Nomination Form
Anadromous Waters Catalog

Name of Waterway 18 Mile Slough USGS Name Local Name

115-32-10250-2060 Route Correction

Figure 1: Map of 18 Mile Slough Route Correction

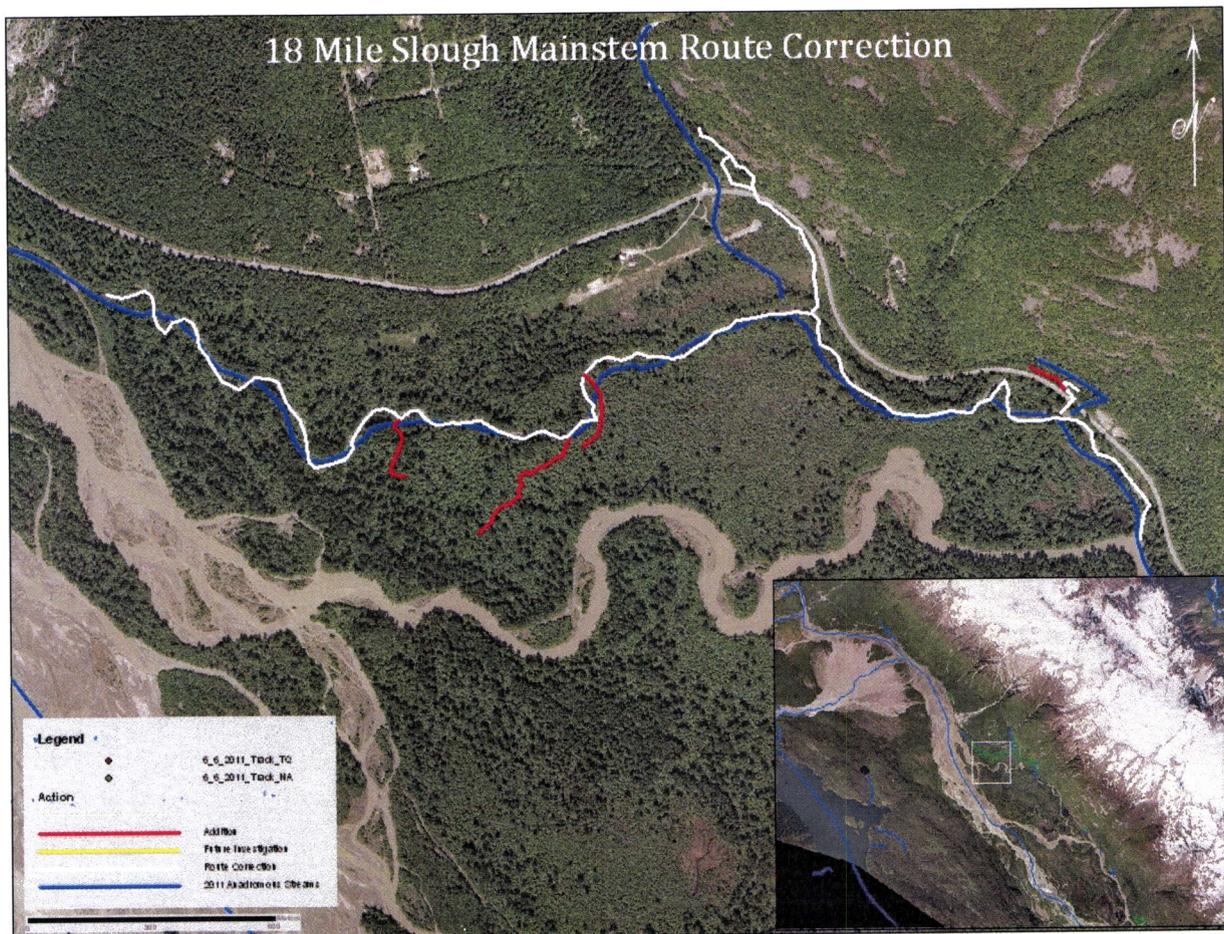
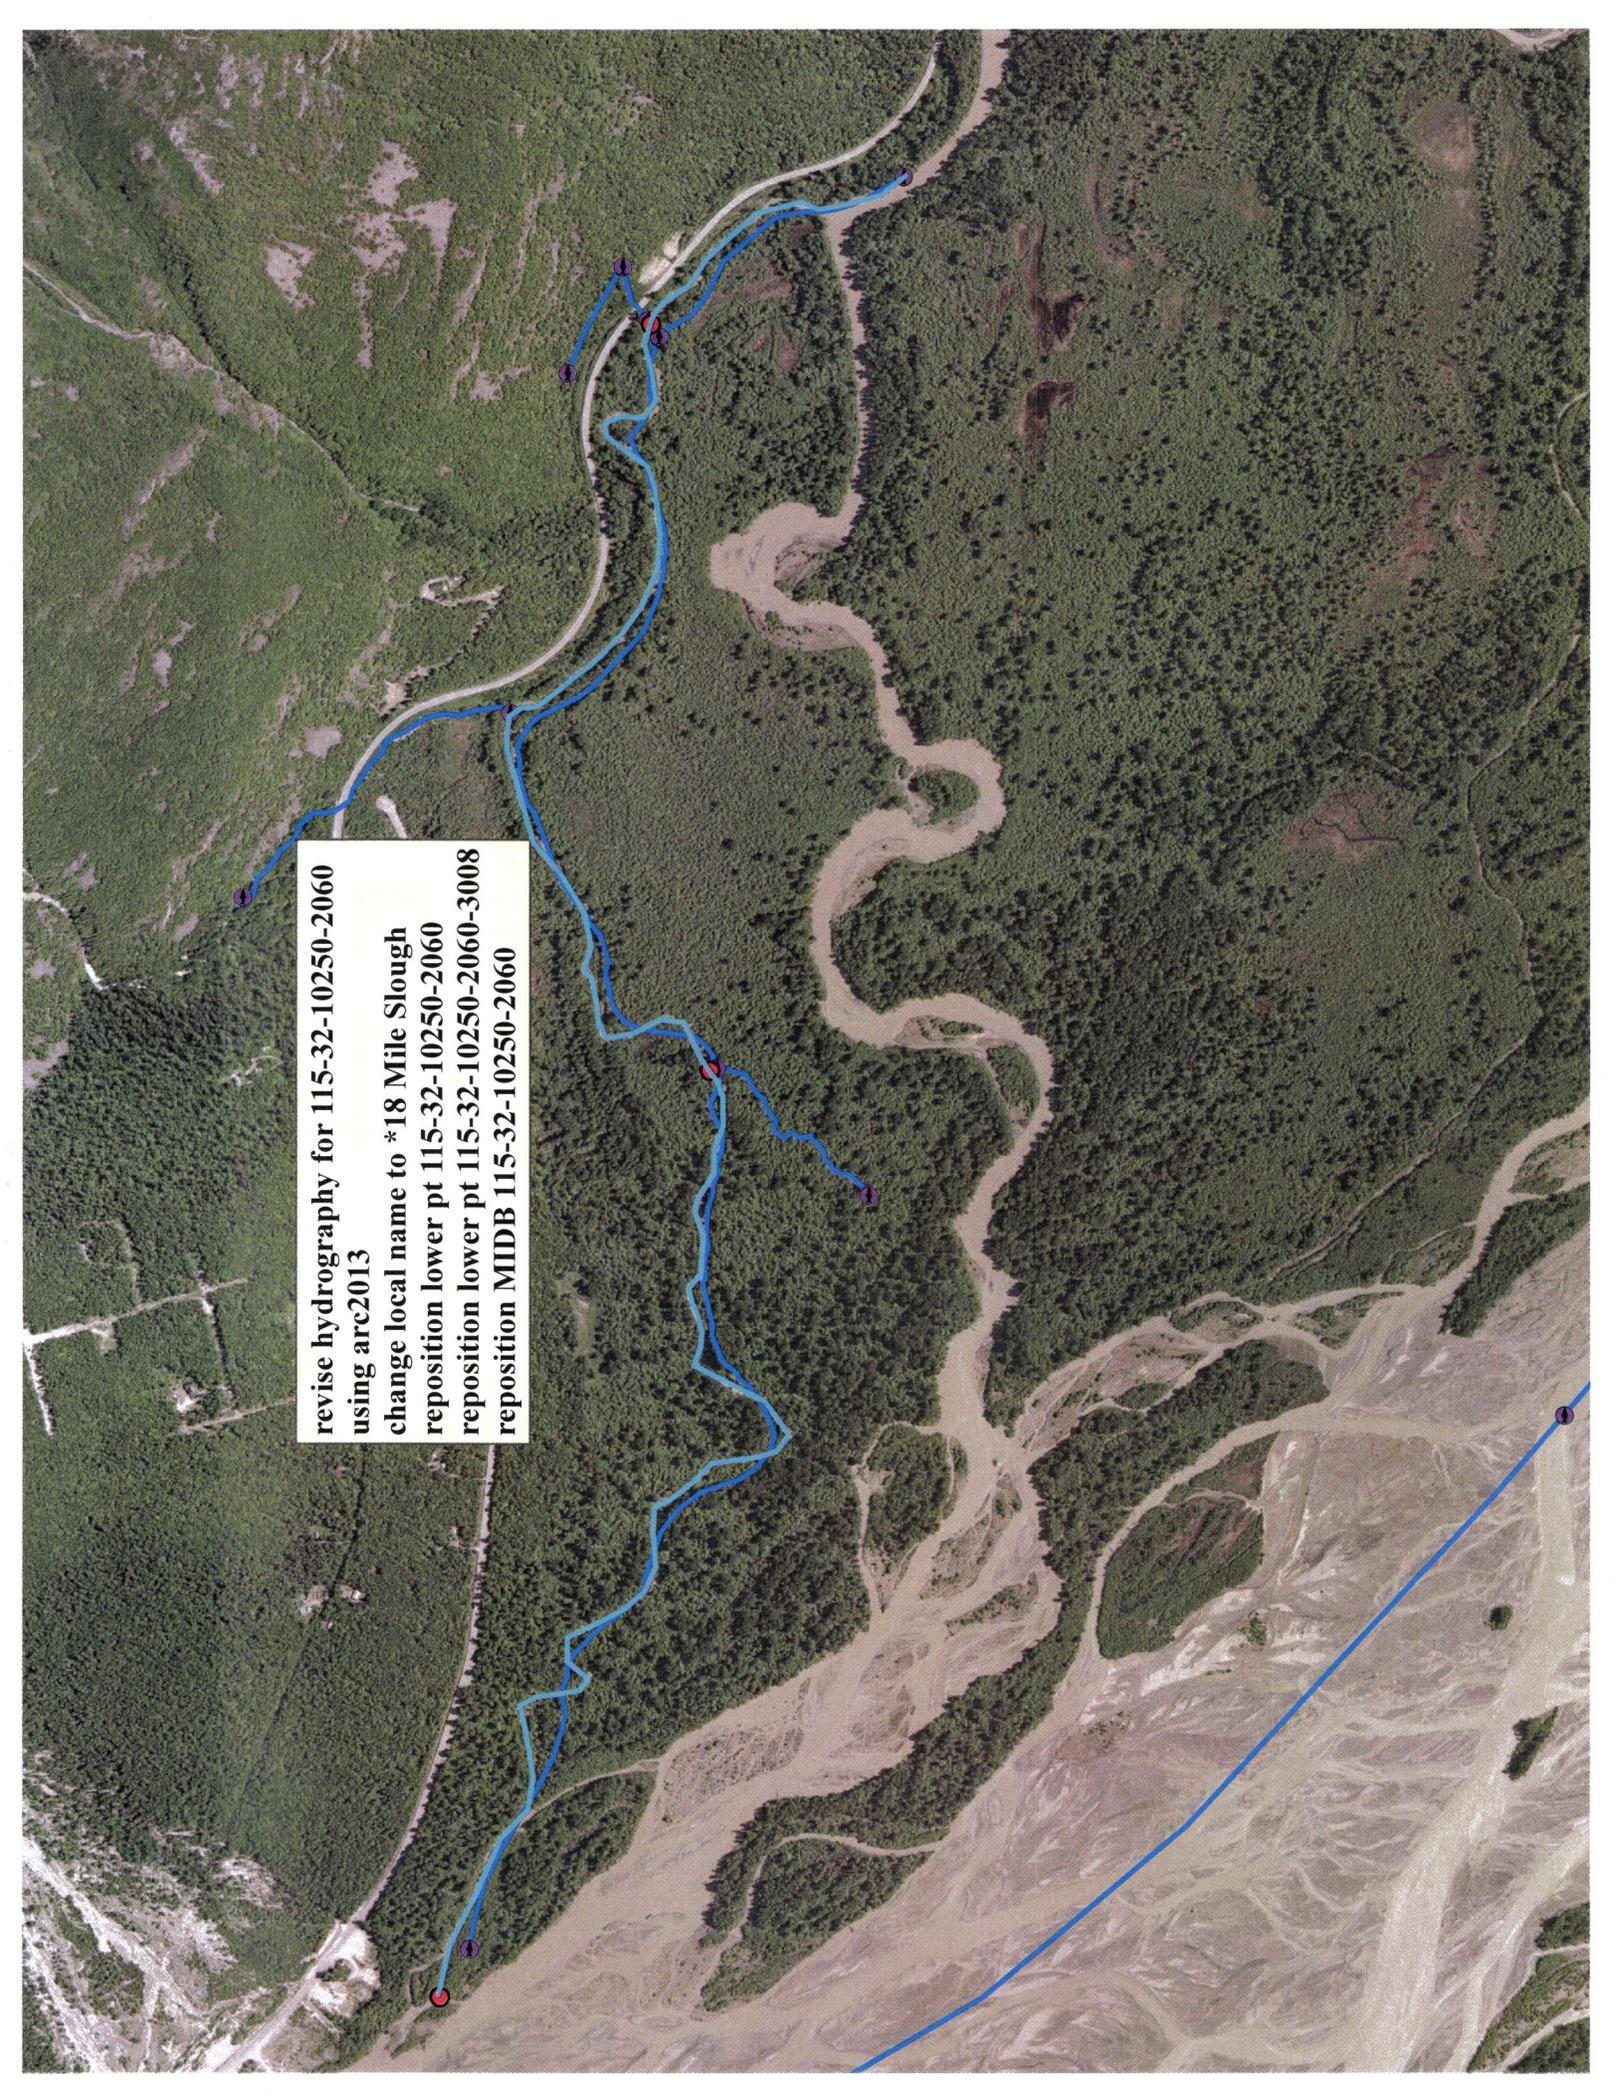
This stream is being nominated for a route correction to reflect its sinuous complexity.
Coordinates (Lat,Long): Upper(59.367109,-135.828276) Lower(59.356937,-135.787766)

Findings: This stream's sinuosity is more complex than what is currently cataloged.

Recommendations: Correct the route of this stream in the AWC

**revise hydrography for 115-32-10250-2060
using arc2013
change local name to *18 Mile Slough
reposition lower pt 115-32-10250-2060
reposition lower pt 115-32-10250-2060-3008
reposition MIDB 115-32-10250-2060**
